Construction Change Directive

(name, address)
ALBERTSONS #2250
WICHITA, KANSAS

DIRECTIVE NO.: S-04

ALBERTSON'S - WICHITA, KS

ALBERTSON'S - WICHITA, KS	DESIGNED BY MNP	JOB NUMBER 27000038.250
	APPROVED BY DTA	STORE NUMBER 2250
IRRIGATION PLAN - CCD NO. S-04	DATE 7/3/97	SCALE 1" = 20'
	SHEET NUMBER IR102.4-1

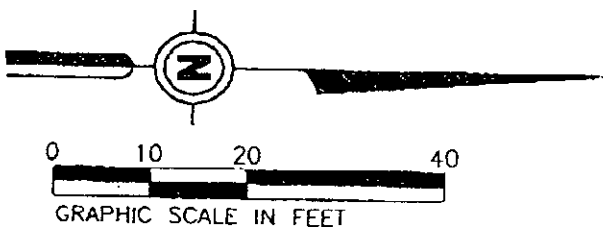
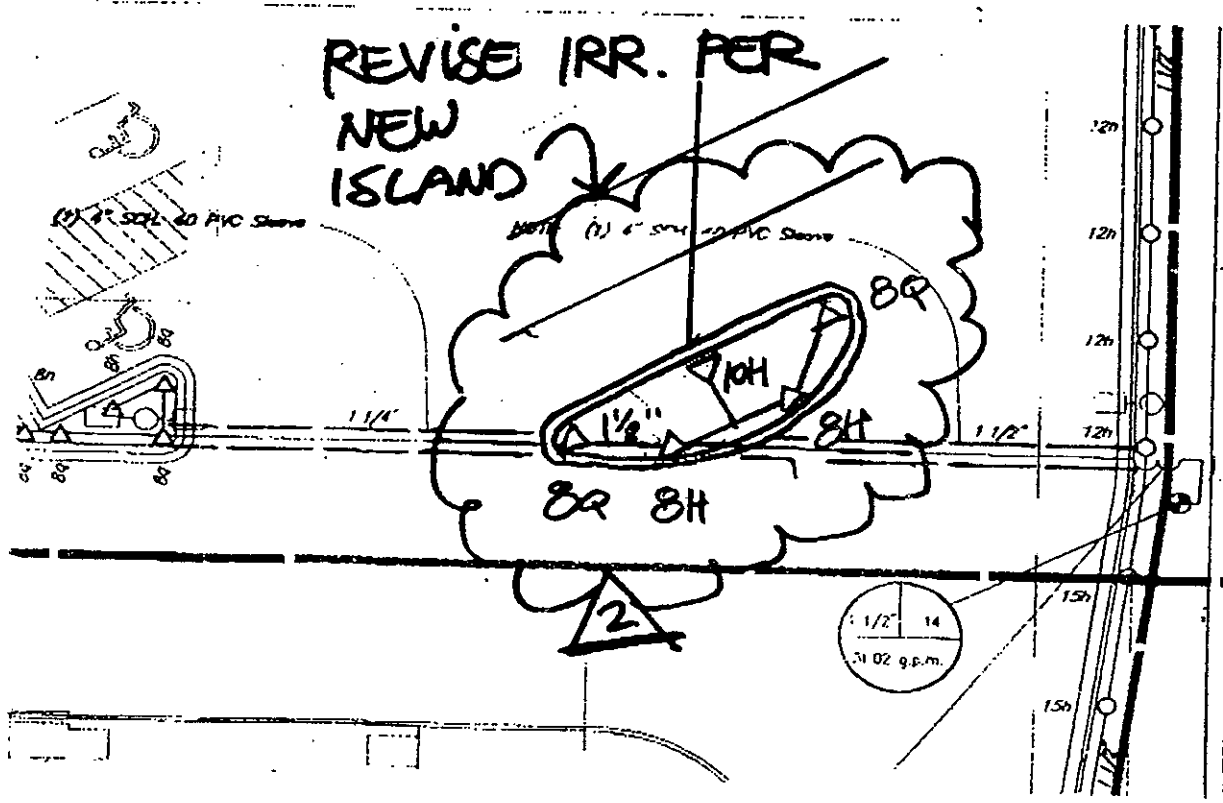
IR102, IRRIGATION PLAN

1. Made adjustments for the northerly island modification.
